**CITY OF SUNNYVALE
REPORT
Planning Commission**

SUBJECT: Application(s) for an 8,085 square foot site located at **1649 Kamsack Drive** in an R-1 Zoning District (APN: 320-16-048):

Motion **2007-1096:** Design Review to allow a 1,569 square foot two-story addition to an existing one-story home for a total of 3,789 square feet and 46.8% FAR (Floor Area Ratio) where 45% may be allowed without Planning Commission Review.

○ EAST (STREET) ELEVATION

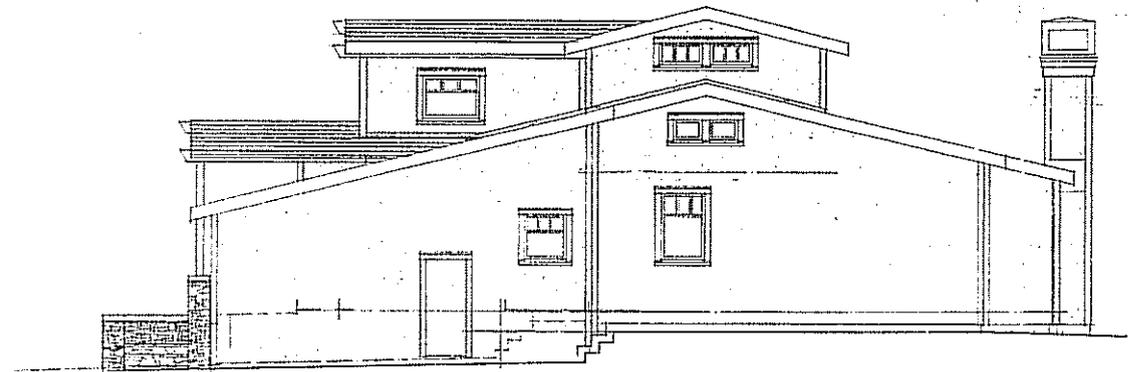
Single Family Home Design Techniques	Comments
<i>3.2D Do not locate garages forward of other habitable portions of the house unless that is the predominant pattern in the neighborhood.</i>	The Kamsack Drive neighborhood consists of modest ranch-style homes with garages that are forward and dominate the streetscape.
<i>3.2E For two car garages, divide the openings to provide one door for each vehicle unless the common condition along the street front is wider doors.</i>	Although most homes in the project neighborhood still display the original wider garage doors, the project does provide visual interest and detail by dividing the doors while still displaying one wide garage frontage plane.
<i>3.3 Design entries to be in scale and character with the neighborhood.</i>	The proposed front door entry is one story in height and functions as a forward portion of the porch. The front entry is too high and should be reduced in order to keep it in scale with the neighborhood.

Single Family Home Design Techniques	Comments
<i>3.3A Locate home entries so that they are visible from the street.</i>	The proposed entry faces Kamsack Drive and is visible to the street.
<i>3.3B Provide an entry porch if that is a common feature of homes in the neighborhood. Match the design to the style of the home.</i>	The original ranch-style homes in the project neighborhood have low roof overhangs located horizontally across the front elevation. Some homes have created porches. The details of the proposed porch match the style and scale of the project house and of the neighborhood.
<i>3.3 D Eave lines at entries should match or be within approximately twenty four inches of the height of entry eaves in the neighborhood (i.e. close to the first floor eave height). In no case should front entry eaves be substantially higher than the first floor eave.</i>	The applicant has maintained the first floor eave height of the first story of the house. The front entry feature is approximately three feet higher than the porch in order to accommodate high entryway windows tucked under the entry roof. Staff recommends that the entry feature roof be lowered to match the adjacent porch eave height and the typical height in the neighborhood.

Staff finds that the proposed addition would result in a home that meets the Sunnyvale Single Family Home Design Techniques and is compatible with the surrounding neighborhood. Staff recommends that the front entry feature be redesigned with a lower roof to match the predominate roof heights in the neighborhood.

- A. The plans shall be revised to be consistent with the Sunnyvale Single Family Home Design Techniques by lowering the roof of the front entry feature to match the roof of the adjacent porch as approved by the Director of Community Development prior to issuance of a Building Permit.
- B. Final exterior building materials and color scheme are subject to review and approval of the Director of Community Development prior to issuance of a building permit.
- C. Roof material shall be cedar shake as indicated on the plans approved at the public hearing or 50-year dimensional composition shingle, or as approved by the Director of Community Development.

○ WEST (REAR YARD) ELEVATION

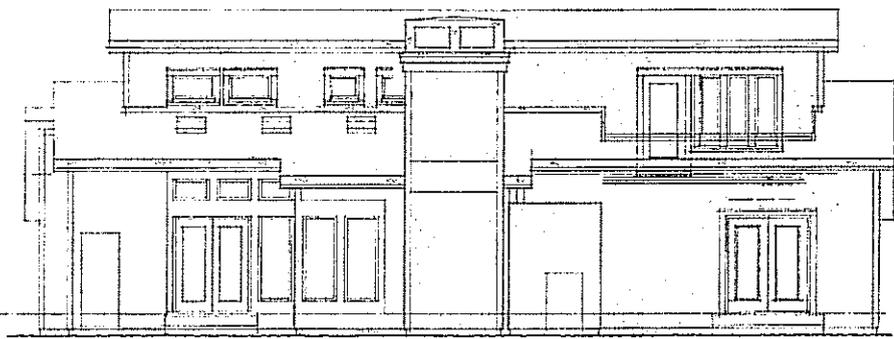
Expected Impact on the Surroundings: The project meets or exceeds all required setbacks for both the first and second story. The rear yard second story setback is 40 feet to the rear wall of the house with a second story deck

that extends 11 feet towards the rear yard with a setback of 29'. On the side elevations, the windows are high-sill bedroom windows and high, larger windows that are open to the entry way below.

Although the rear, second-story deck may provide some views to adjacent rear yards, the 29' set back is significant.
